**BC Timber Sales  
Albreda 2015  
Visual Assessment and Recommendation  
RDI Resource Design Inc**

Blocks Investigated November 19, 2015 (update):

# Notes for Current Proposal Assessment 151119

## Current Proposal - Viewpoint 1731.2 - 151119

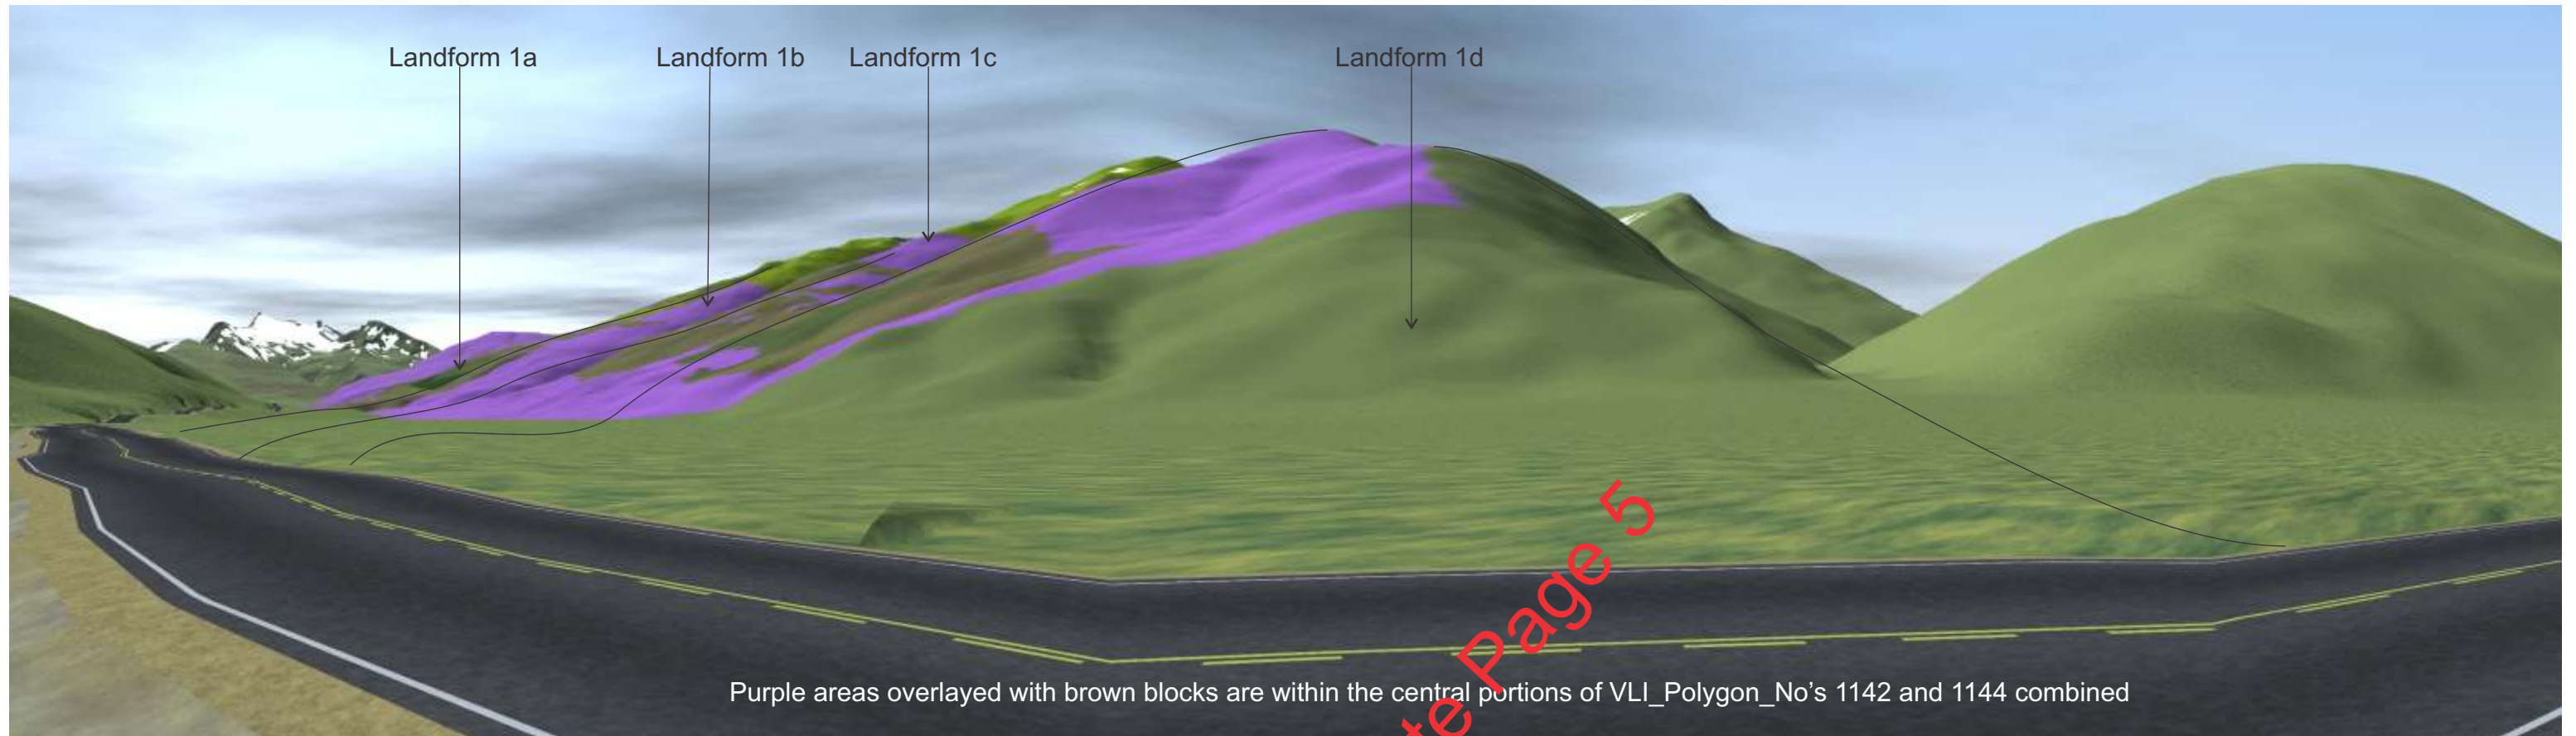
Purple areas overlaid with brown blocks are within the central portions of VLI\_Polygon\_No's 1142 and 1144 combined

See Update Page 5

## Current Proposal - Viewpoint 1733 - 151119

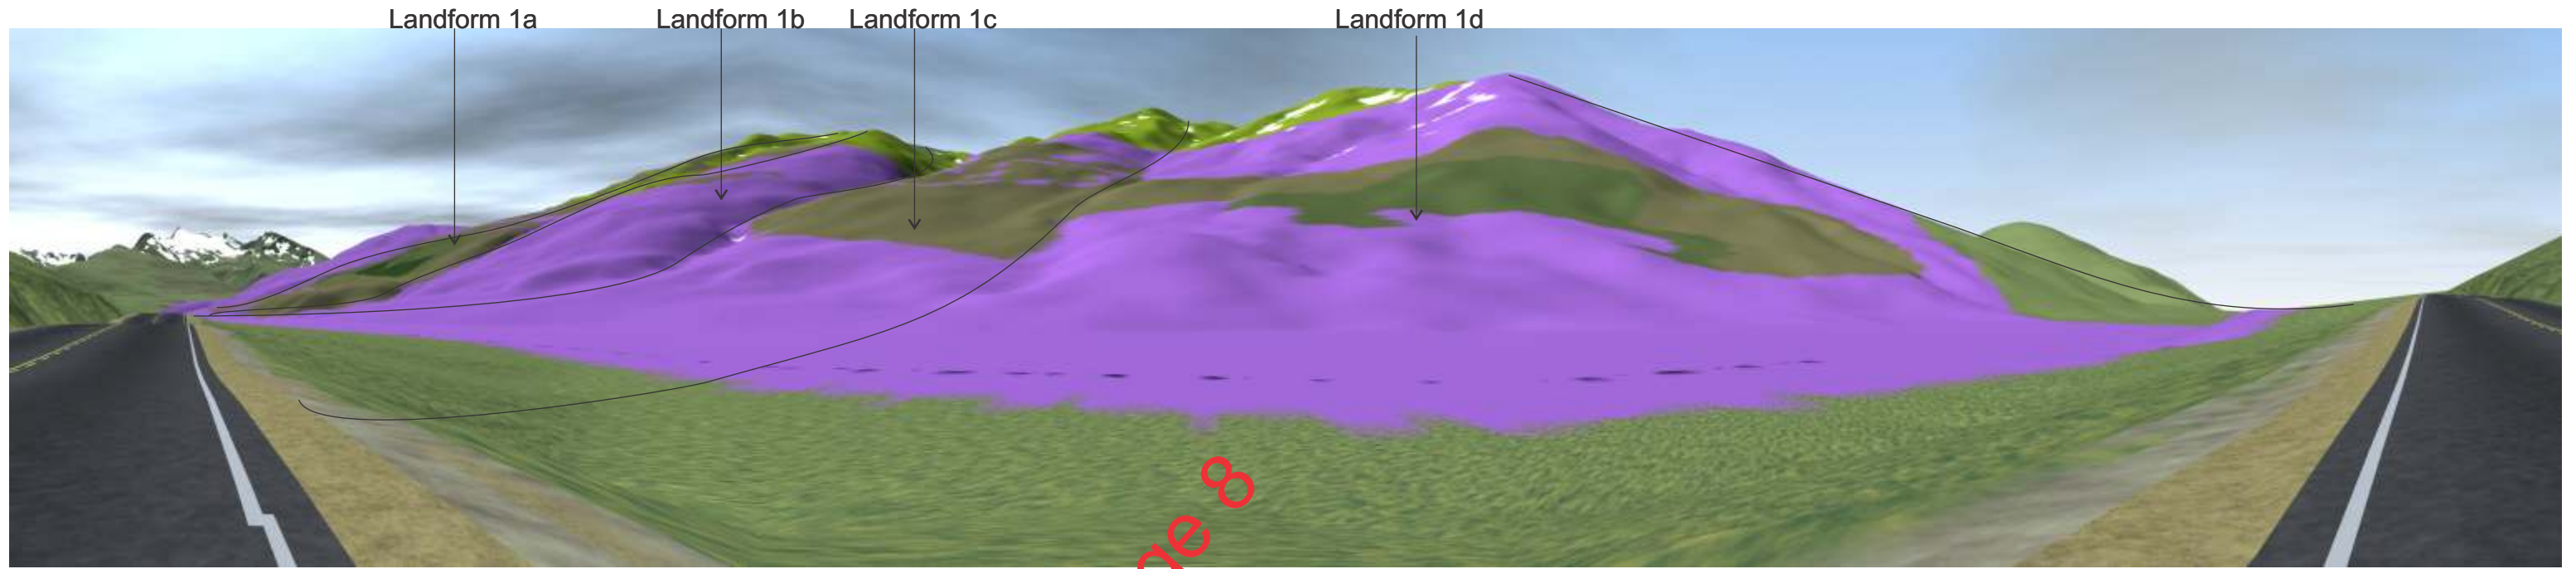
Landform D: AL8QB is now greatly reduced in scale compared to the original proposal. Fairly broad still, and crosses two minor visual force lines, but seen obliquely which diminishes the relative scale. There are few additional opportunities to view directly. AL7NF is mainly NVS except from 1733 where it small. Percent Alteration in Landform D from 1733 is 3.7%. attributed mainly to AL8QB. A56803-1 has been deleted. The image sheet is present at the end of the document.

## Current Proposal - Viewpoint 1734.5 151119

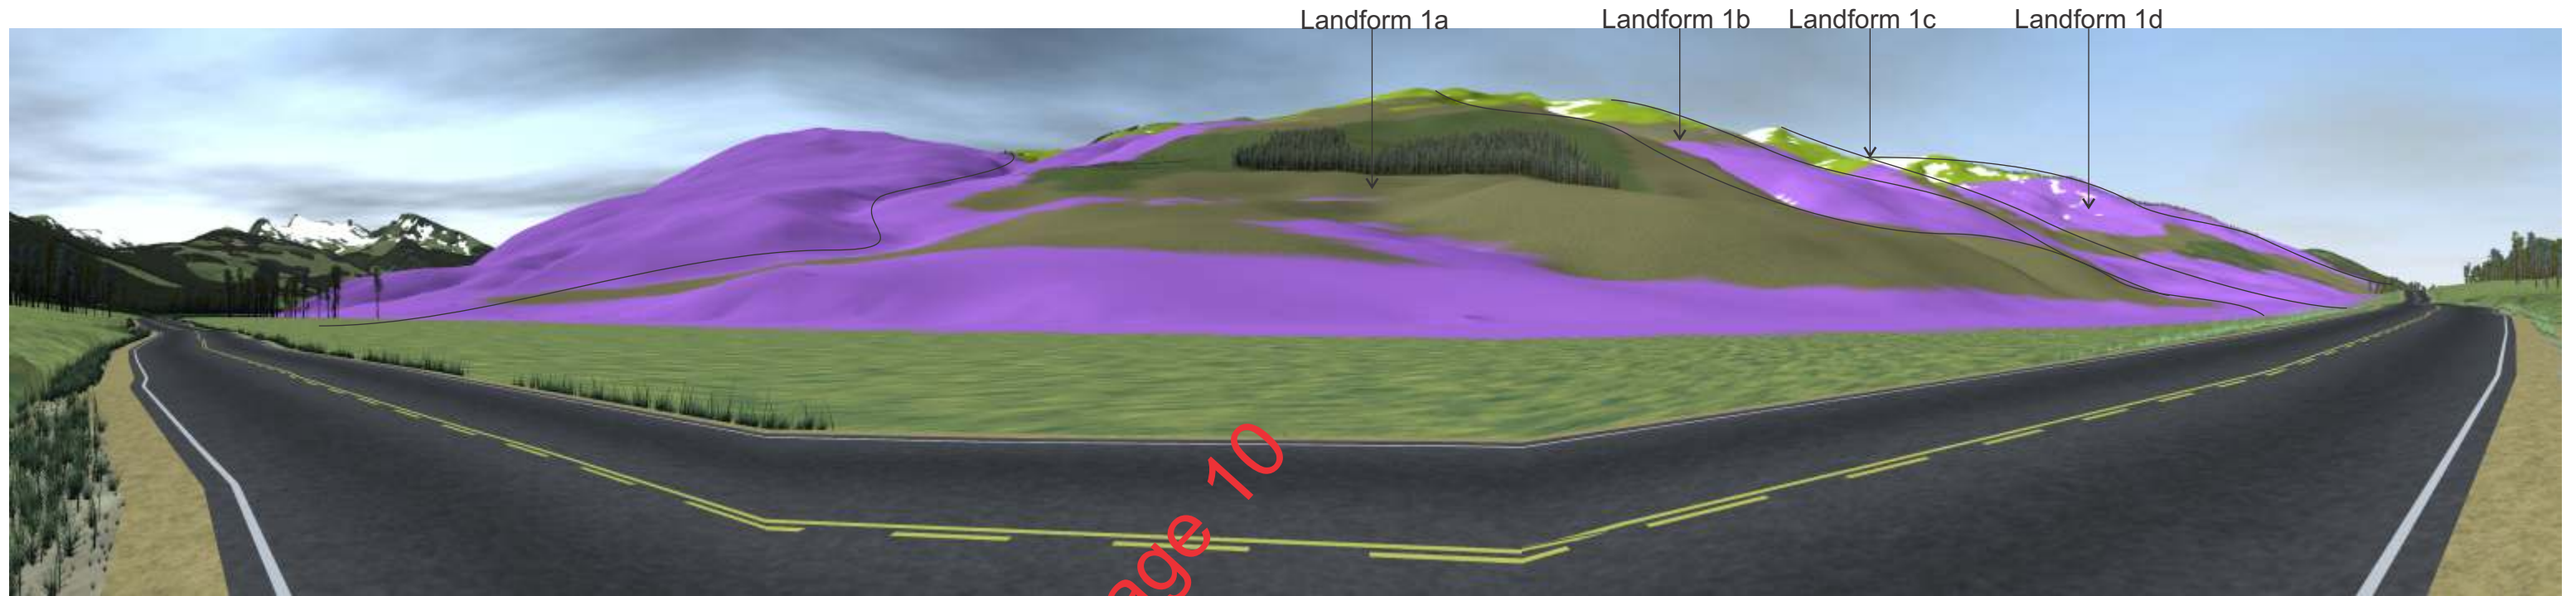
Landform B: AL8PR is small in scale and is only a sliver from VP's 1734.5 and 1733. The block is seen next to the existing AL787 in Landform A, and somewhat exaggerates the scale already present in A, but is on a distinct landform.

Existing AL787 appears larger on left side in rendering compared to photo). See next page for images by block.

## Original Proposal - Viewpoint 1734.5 - Individual Blocks

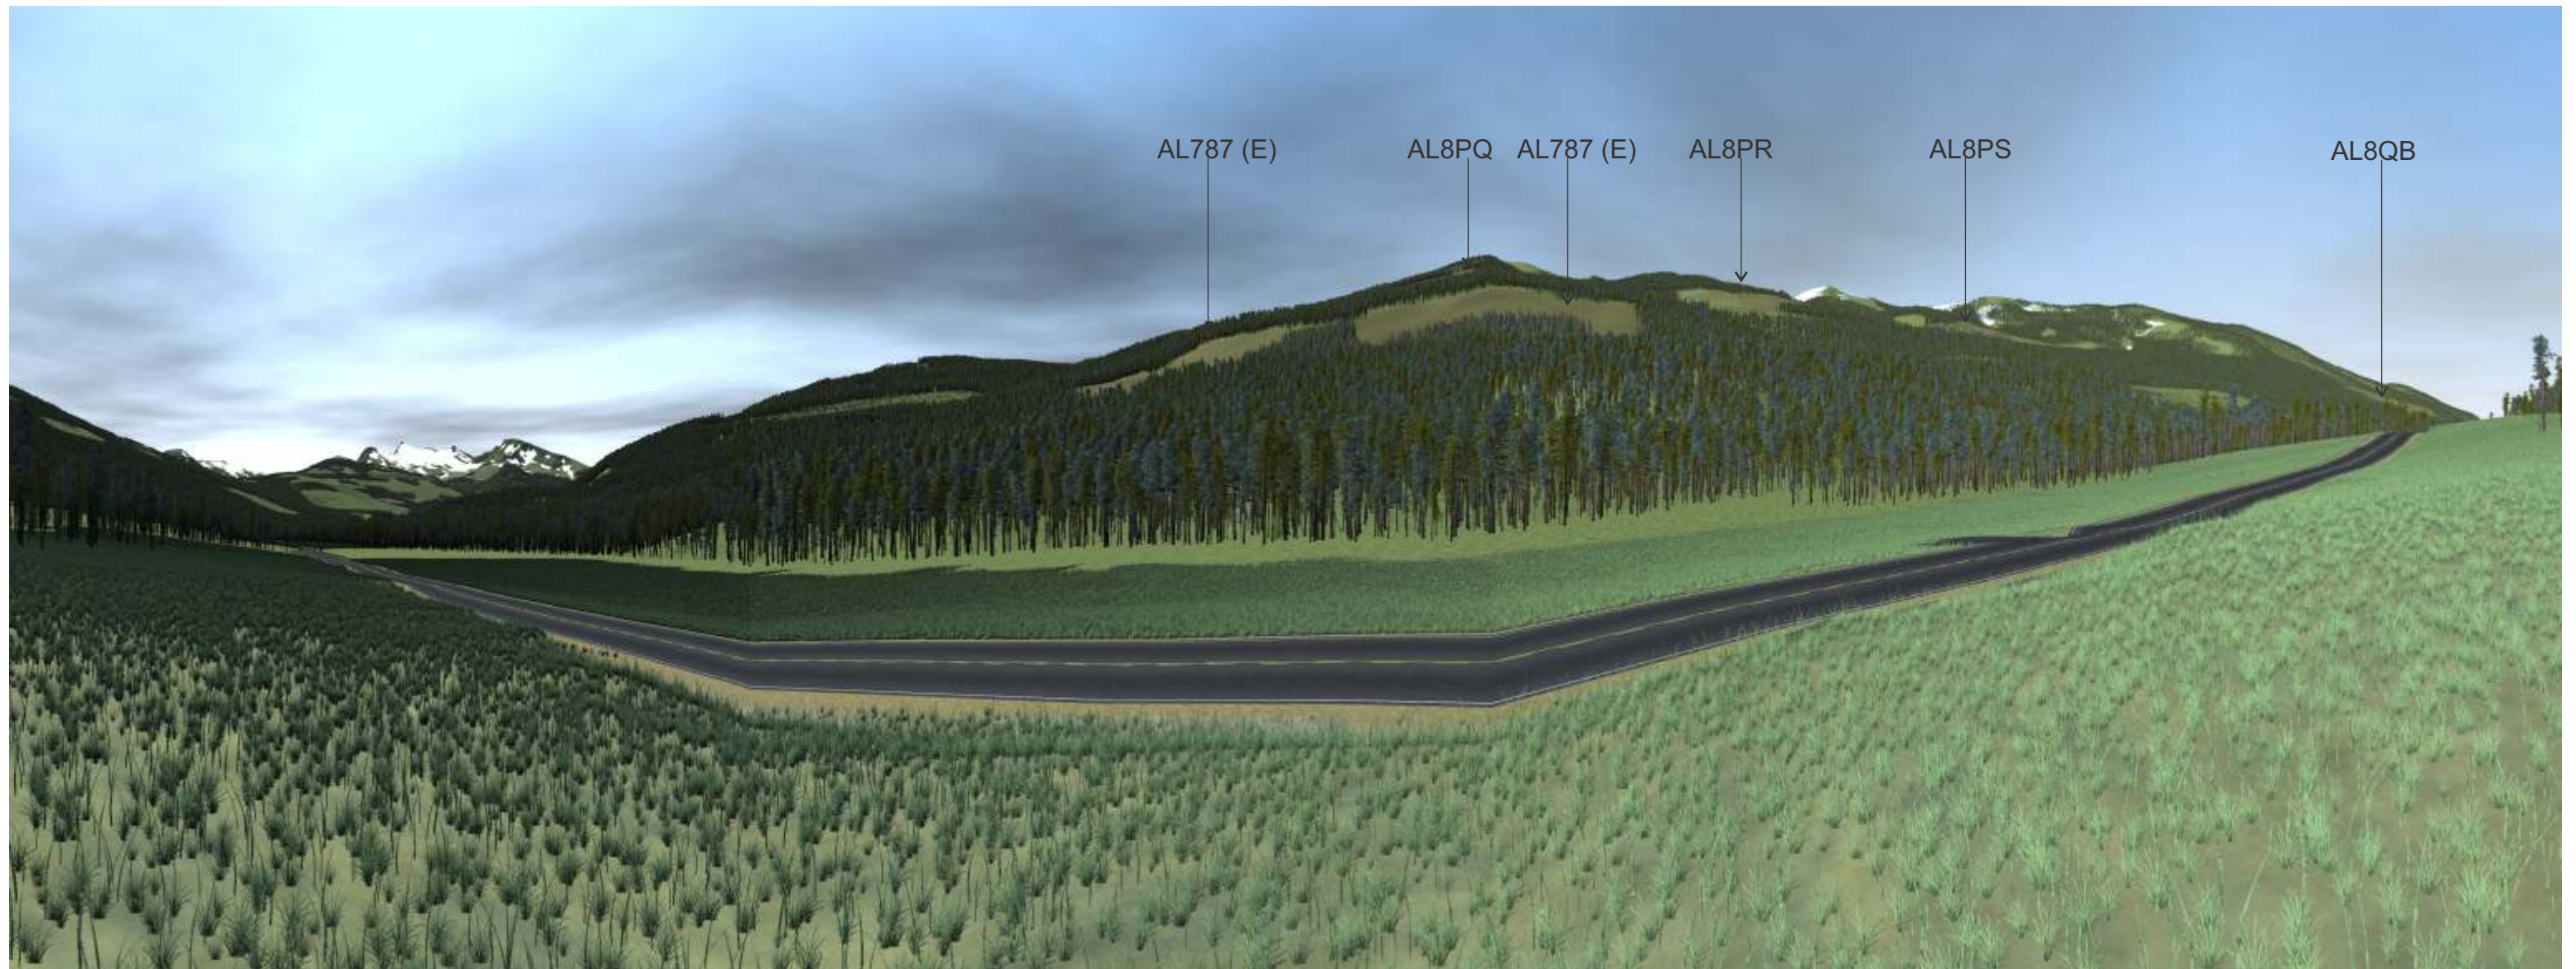
Landform 1a: AL8PT together with existing AL7PT would be excessive (VP 1734.5), though AL8PQ looks OK generally.

Landform 1b: AL8PR looks OK generally from VP's 1734.5 and 1733. You can see the individual effect of AL8PQ in the singles page for that viewpoint in the report.

My conclusion is that AL8PT, AL8PS, AL8QB and A56803-1 all need considerable work, and greatly exceed the PR VQO presently.

## Current Proposal - Viewpoint 1734 - 151119 - Snowmobile Area

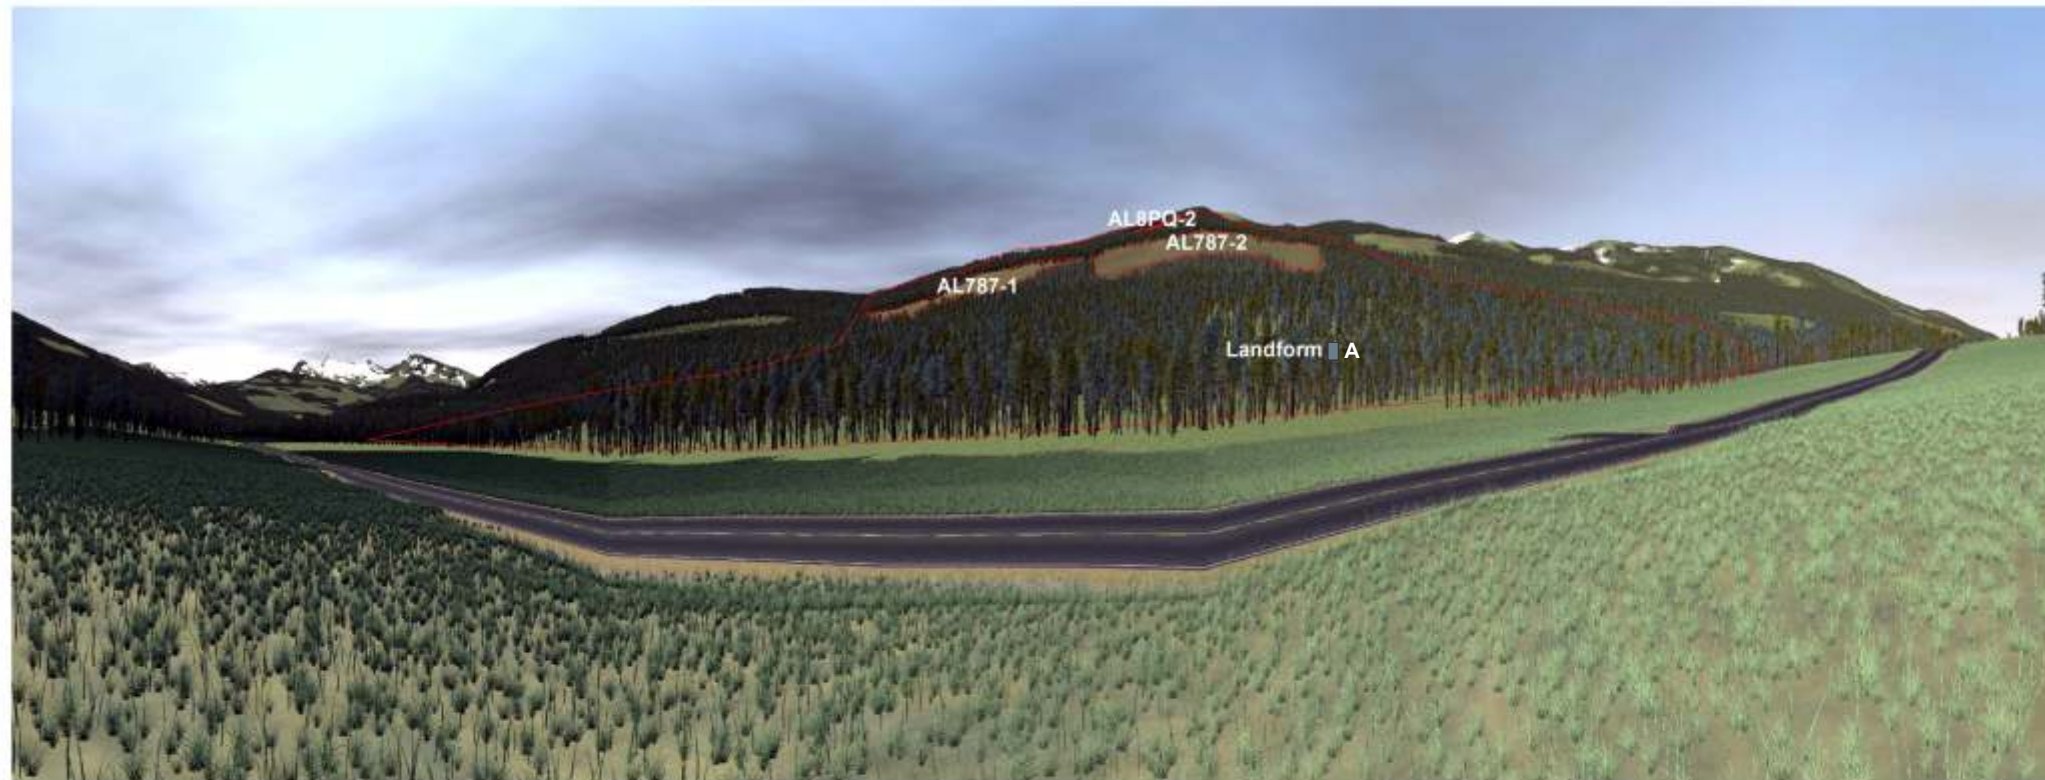
Landform A: Existing AL787 is moderate in scale from VP's 1734.5 Clemina FSR, and 1734 Snowmobile lot, both perpendicular views. AL8PQ is nearly non-visible and does not add significantly to the existing alteration in Landform A. Percent alteration in Landform A calculated from the snowmobile staging area is 4.7%, mainly attributed to existing AL787.

My conclusion is that all cutblocks have been re-worked sufficiently to meet the VQO of Partial Retention. Responsiveness to visual quality considerations is very evident, and is to be lauded. The percent alteration of 4.7% in the 1734 viewpoints is somewhat greater than reality. Existing AL787 appears larger on its left side in the rendering compared to photo. Landform D Percent Alteration from 1733 at Pit Road is worst-case as there is substantial intervening road-side vegetation along Highway 5. Other viewpoints were not checked for percent alteration as they displayed much smaller scale of alteration.

## Current Proposal - Viewpoint 1733 - 151119 - Percent Alteration

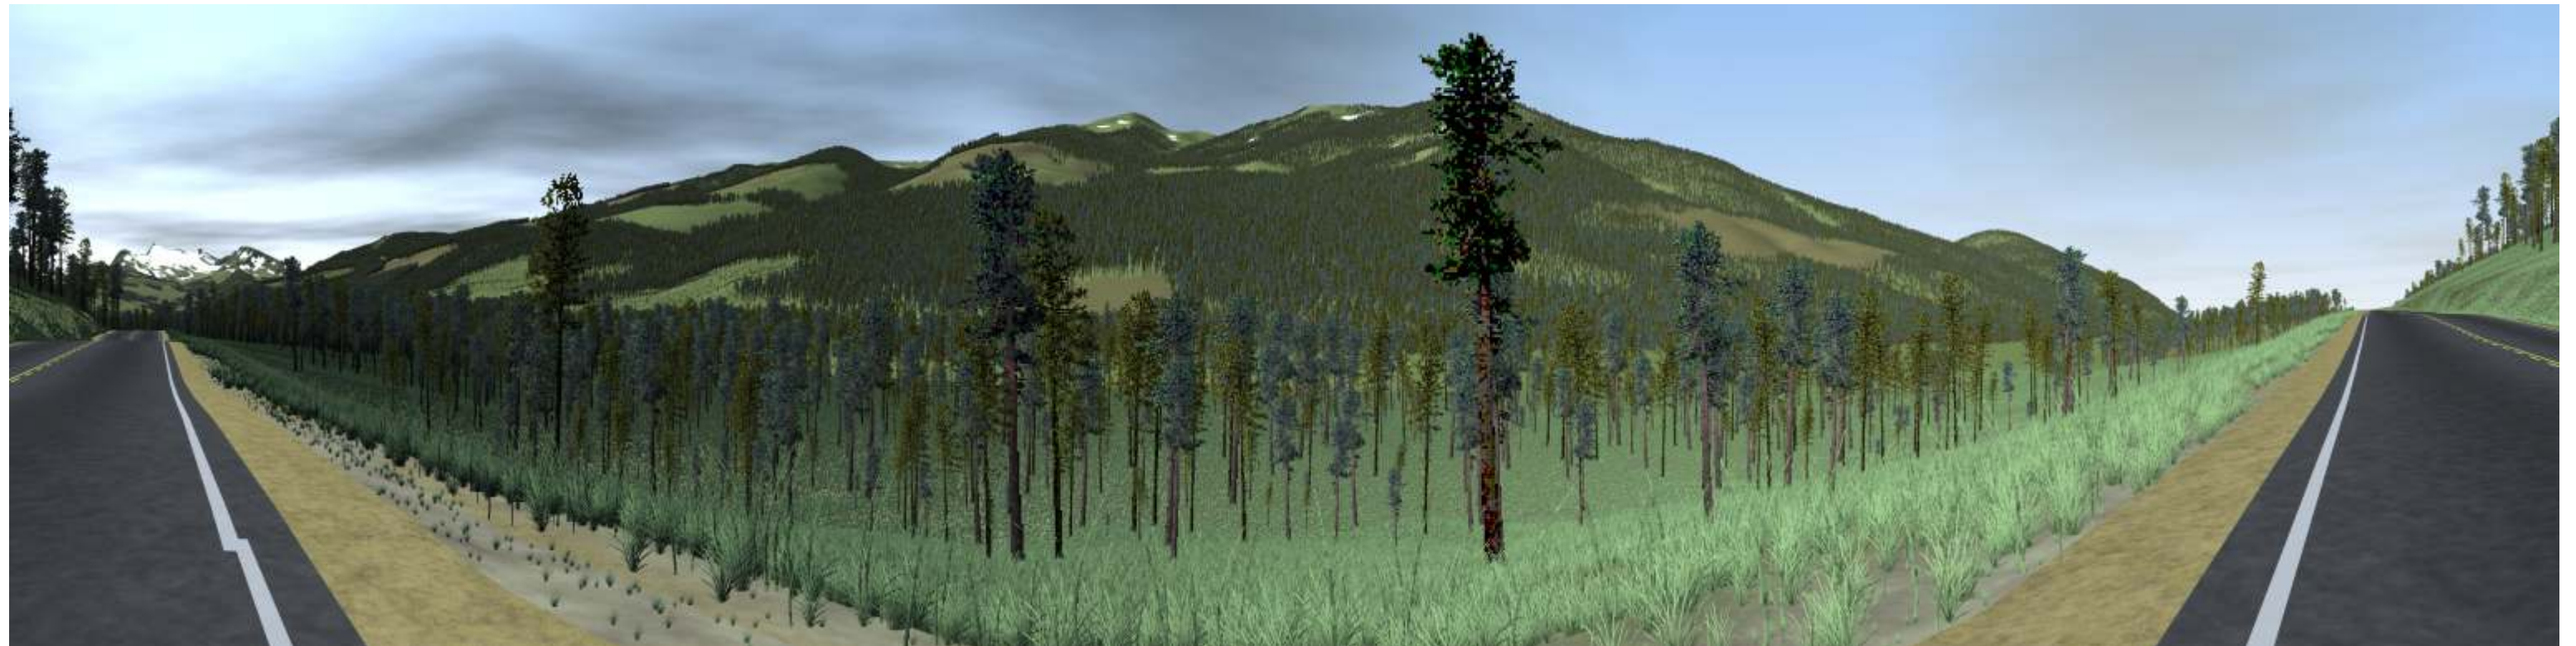
Name	Area_Pers	%Alt.
Landform D	767081.91	
AL7NF	7852.23	1.02%
AL8QB	20936.11	2.73%
Sum Alt.	28788.34	3.75%
